CITY OF KEY WEST

ADDENDUM NO. 1 CAROLINE STREET IMPROVEMENTS / ITB 15-007

This addendum is issued as supplemental information to the bid package for clarification or amending of certain matters of both a general and a technical nature. The referenced Invitation to Bid (ITB) package is hereby addended in accordance with the following items:

Typical Driveway Cross Section

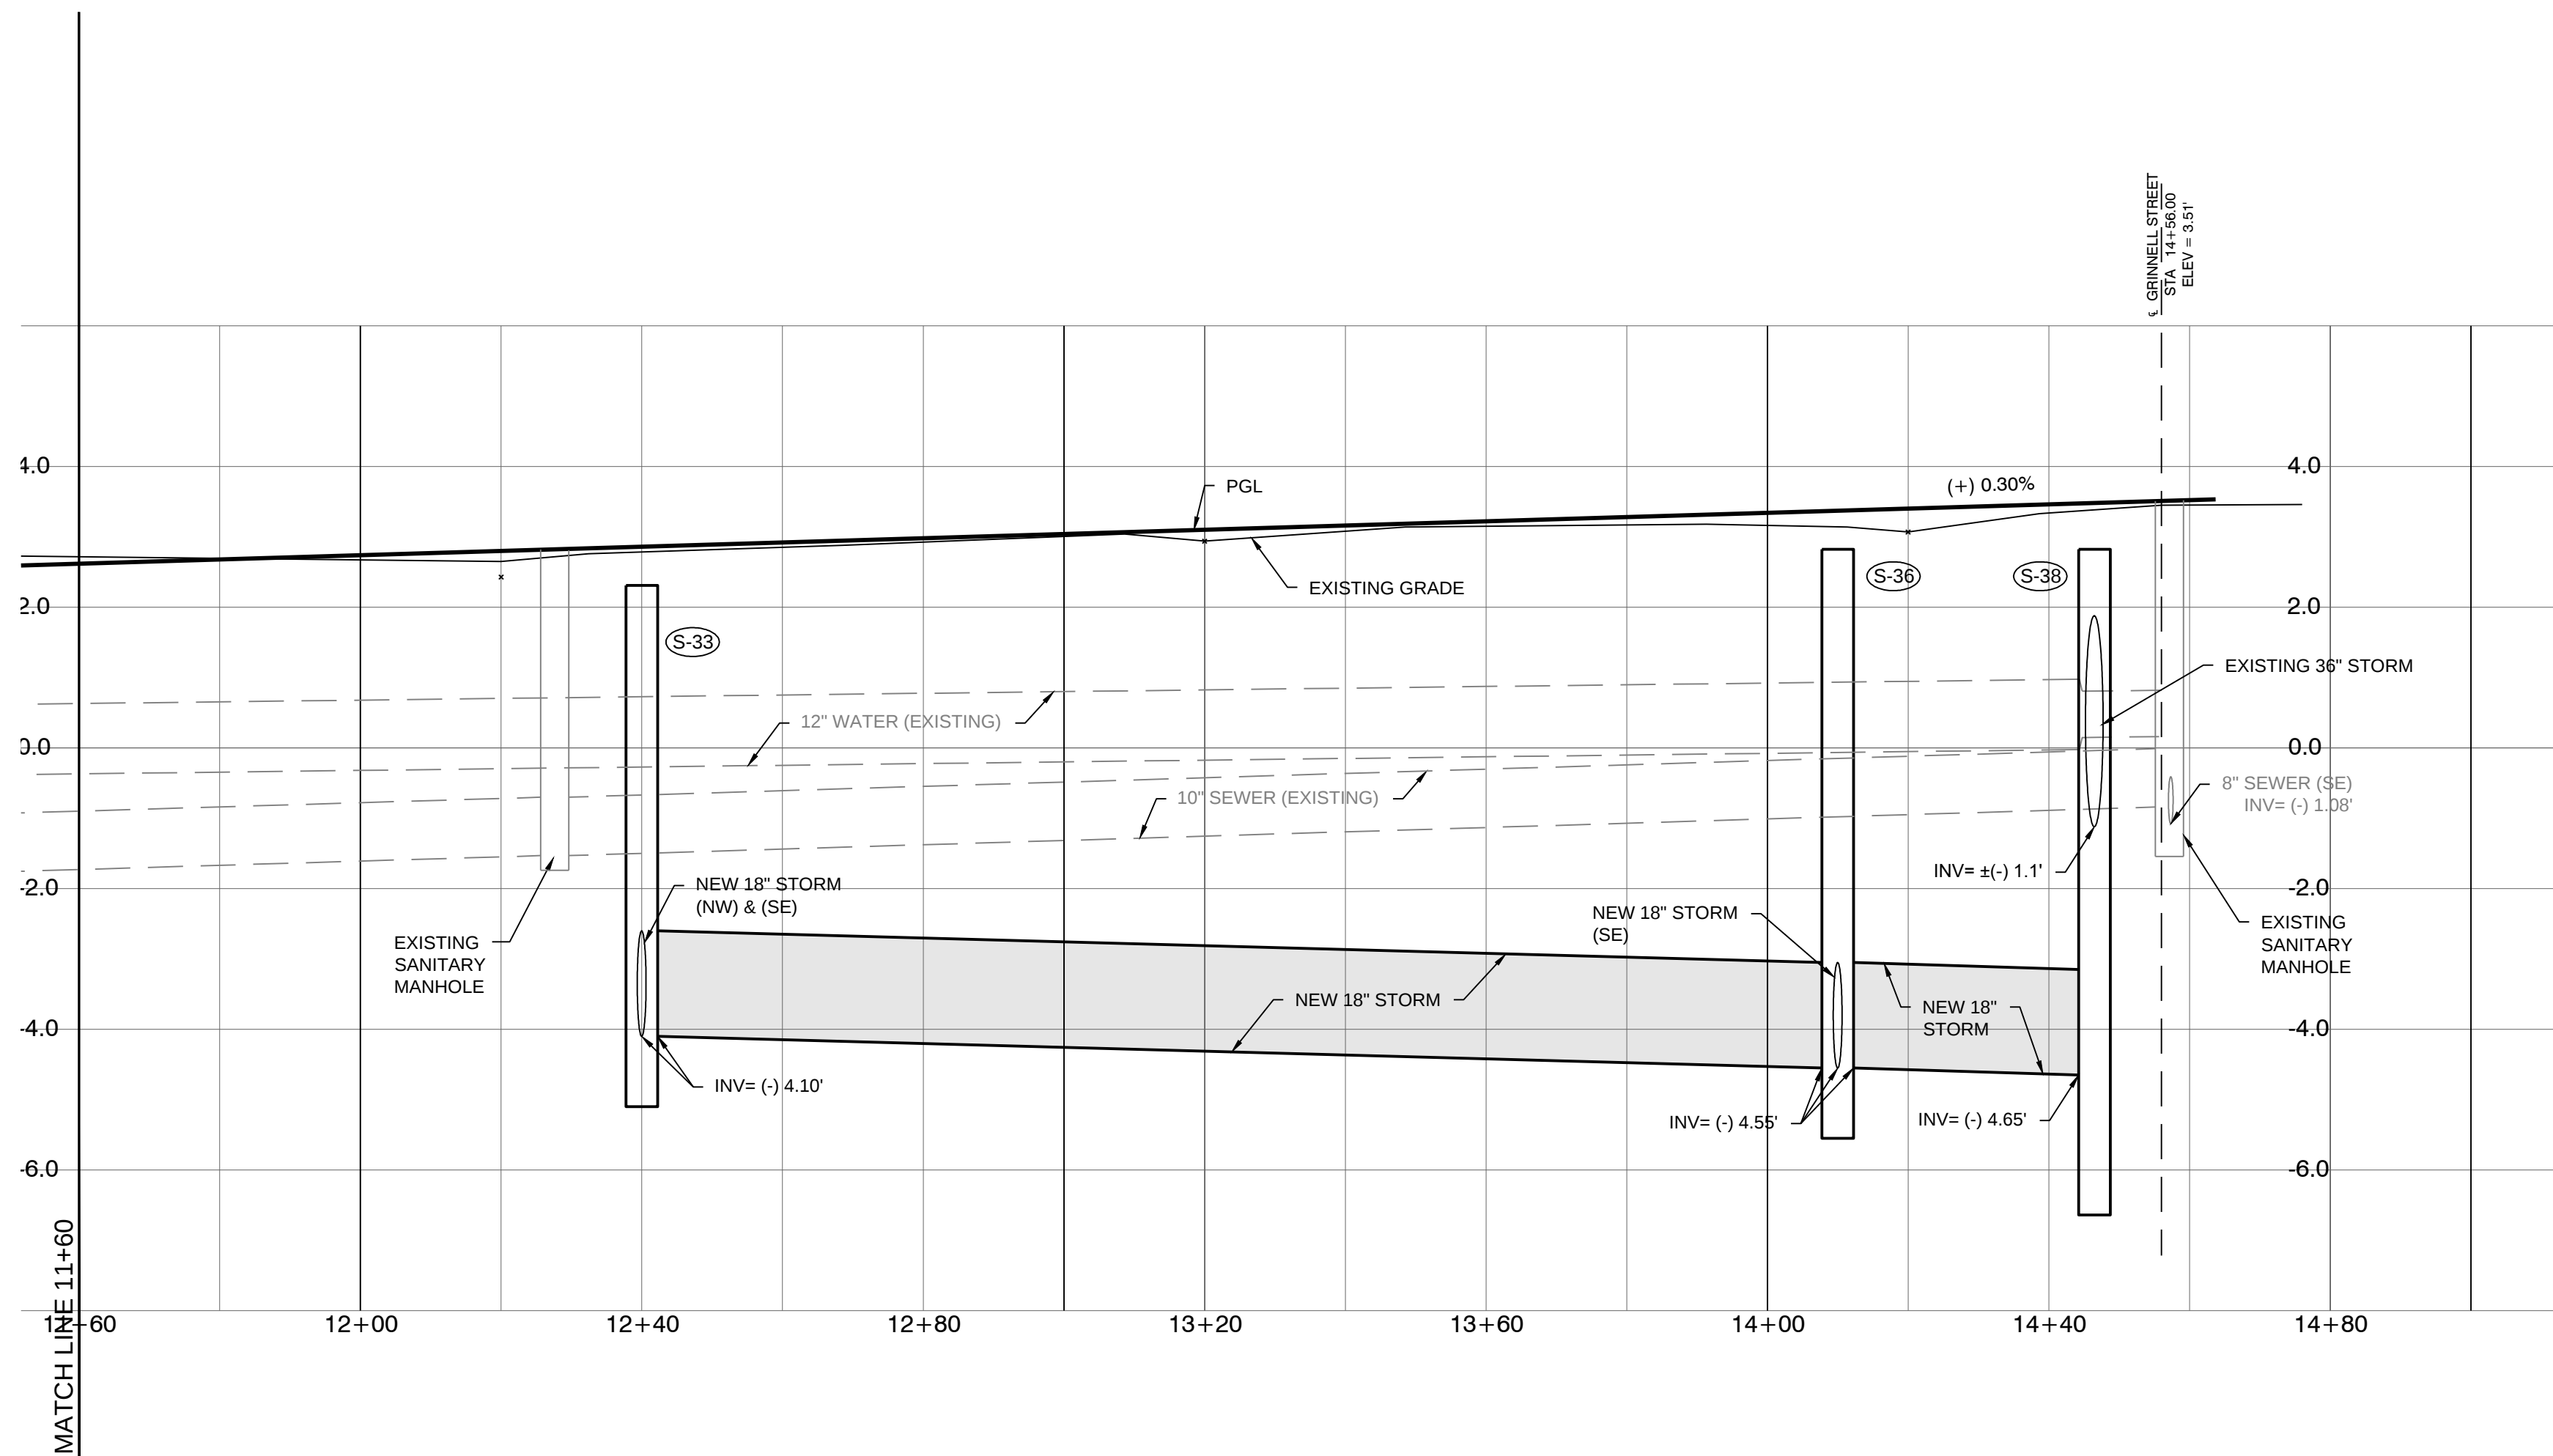
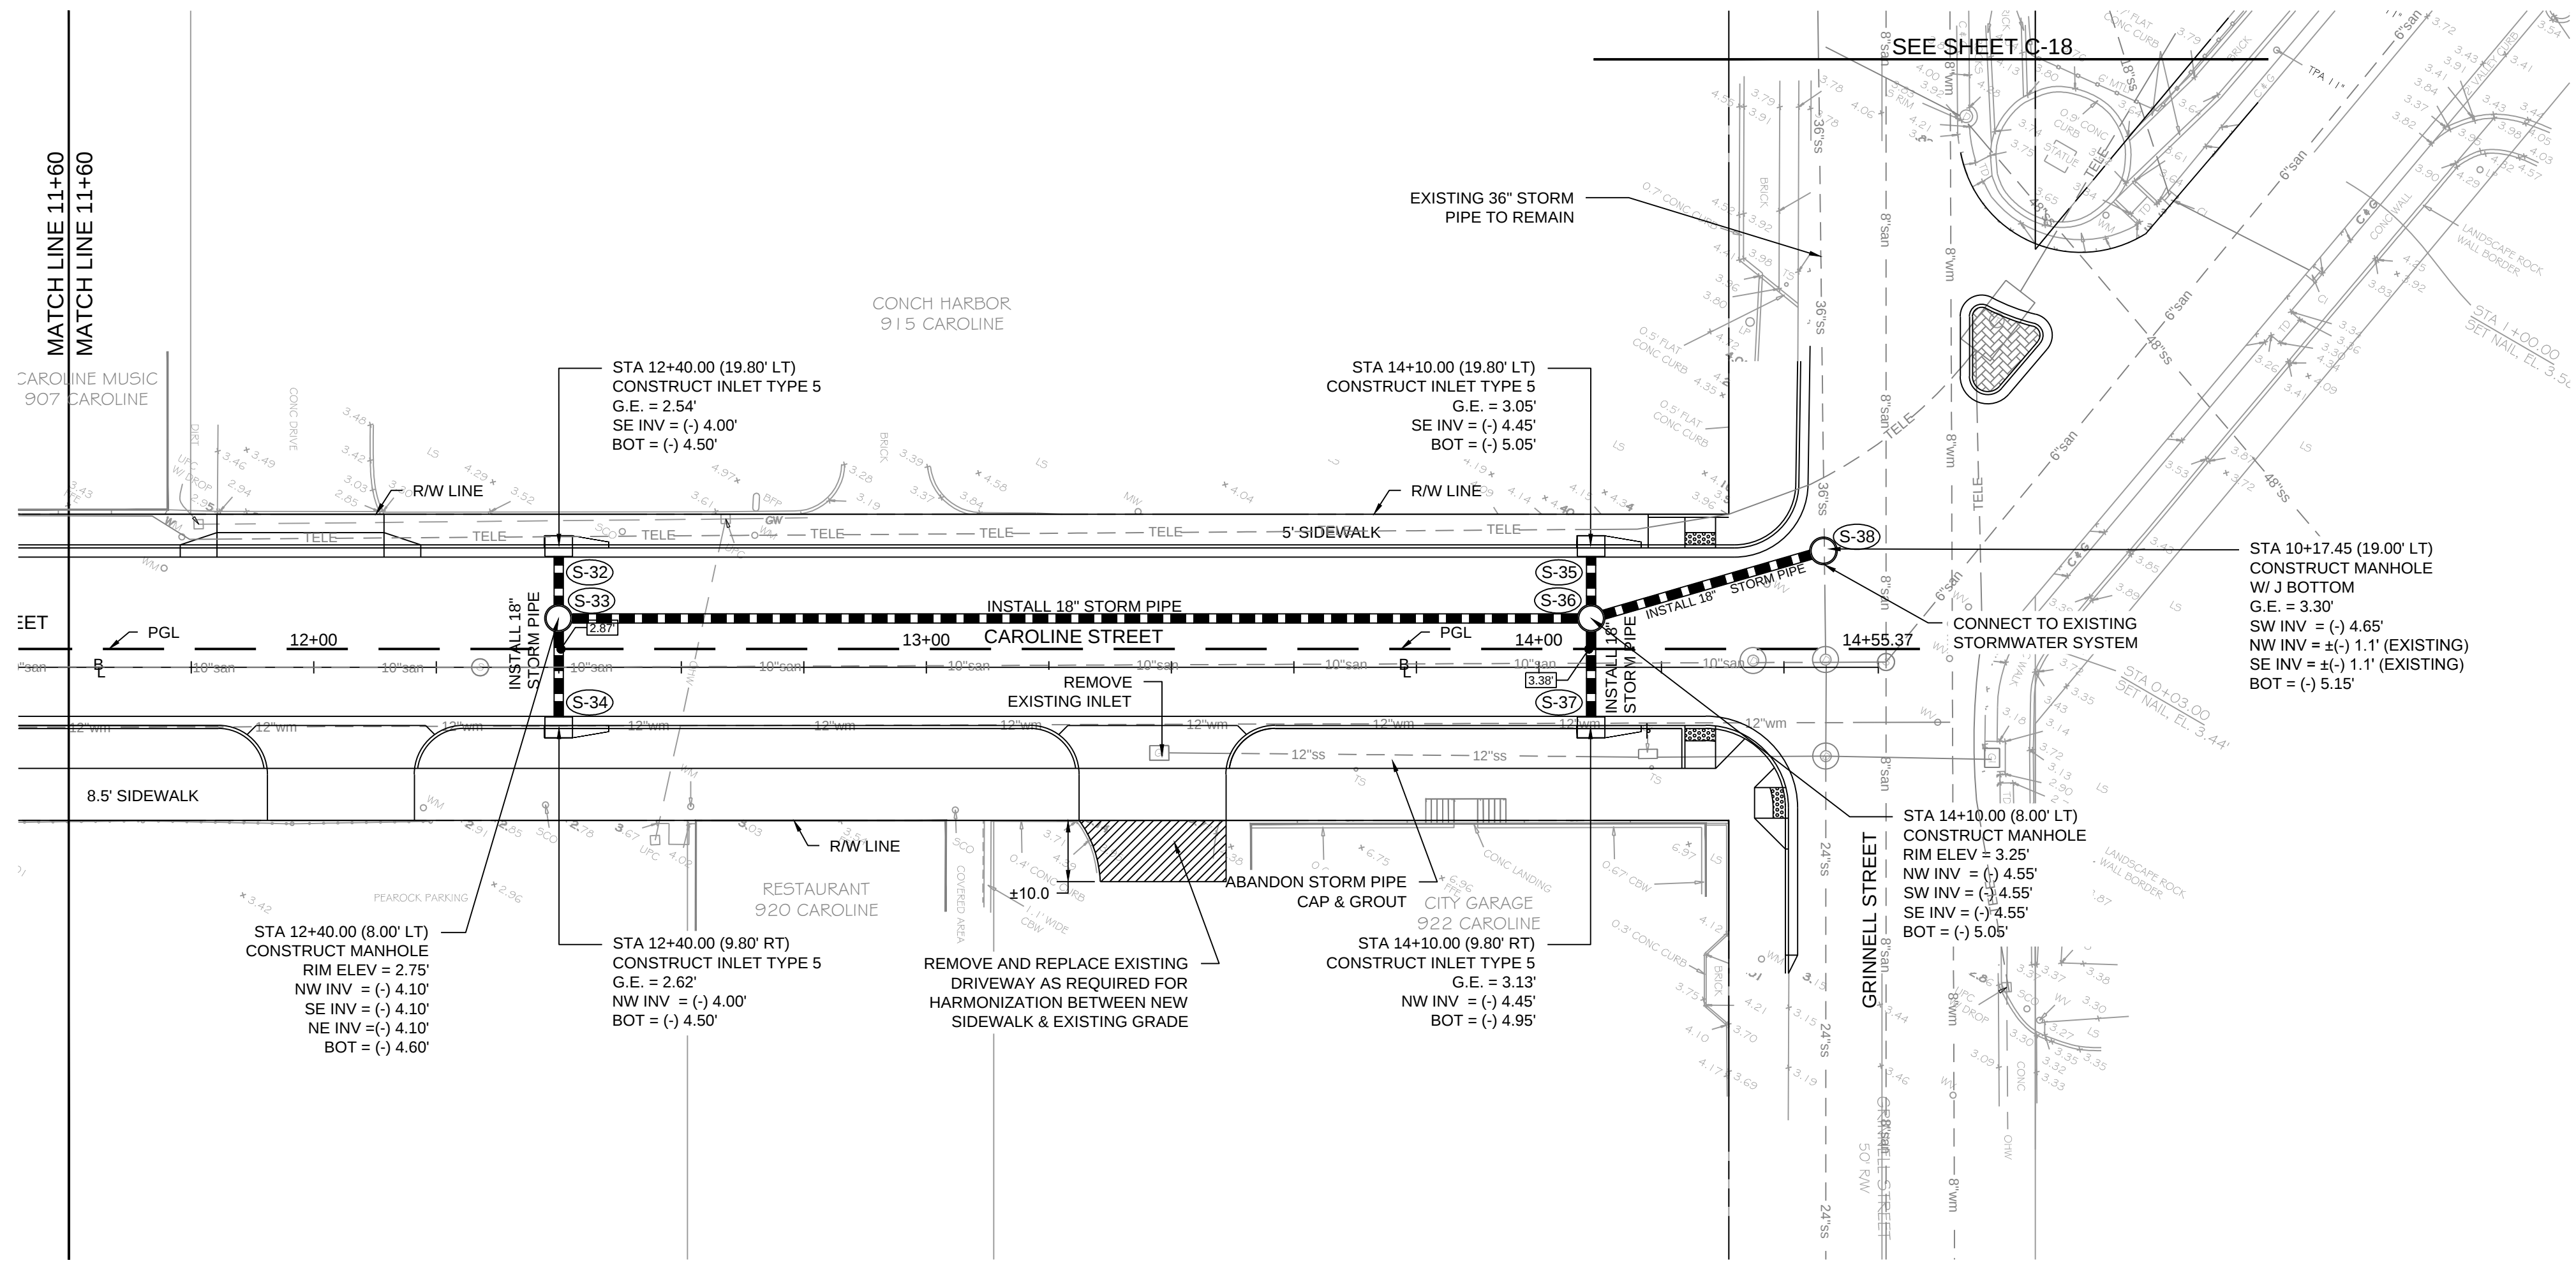
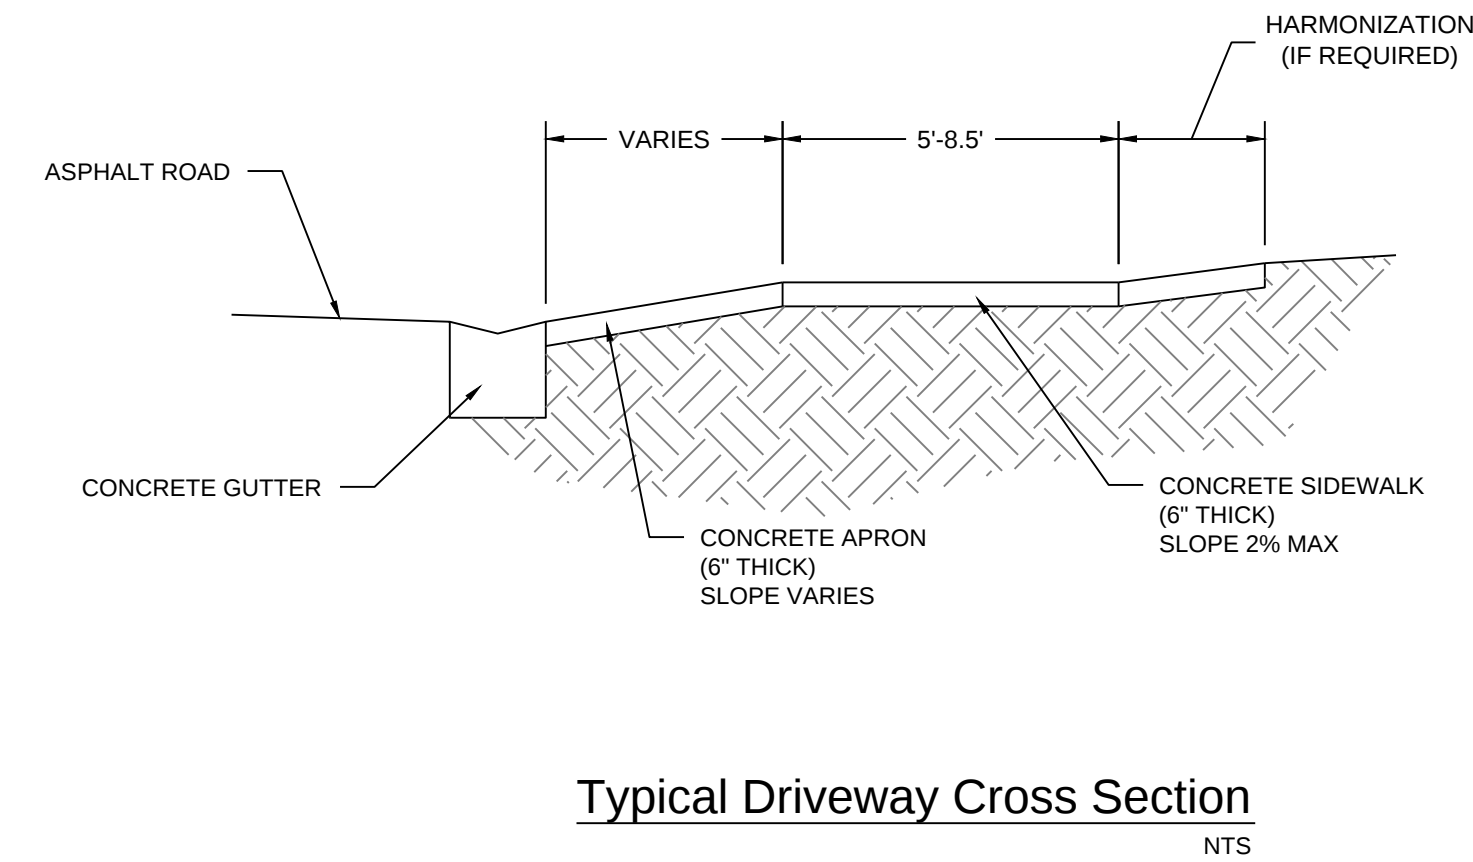
2. Parking Garage driveway replacement/transition on Caroline Street has been described on Sheet C-9 which is attached
3. Bus Parking Area / Sheet C-1 Caroline Street Parking Lot – 900 Block will be issued in Addendum 2 the week of June 22, 2015

<u>Sheet(s)</u>	<u>Description</u>
E-2	LIGHTING PLAN – Corrected “Key Note” to revise lighting circuits to be 2-pole.
C-5	ROADWAY – Lengthened loading zone at approximately STA 8+45 to 72 feet
C-9	DRAINAGE PLAN AND PROFILE – Provided clarification of grading for Parking Garage ramp at approximately STA 13+28
C-10	SIGNING AND PAVEMENT MARKING PLAN – Revision of Loading Zone and Parking Space signage and striping locations and details
C-11	SIGNING AND PAVEMENT MARKING PLAN – Revision of Loading Zone and Parking Space signage and striping locations and details
C-19	PARKING LOT PLAN – Revision to add two (2) pedestrian access/egress points along proposed fence line, 5 feet wide each with steps as applicable.
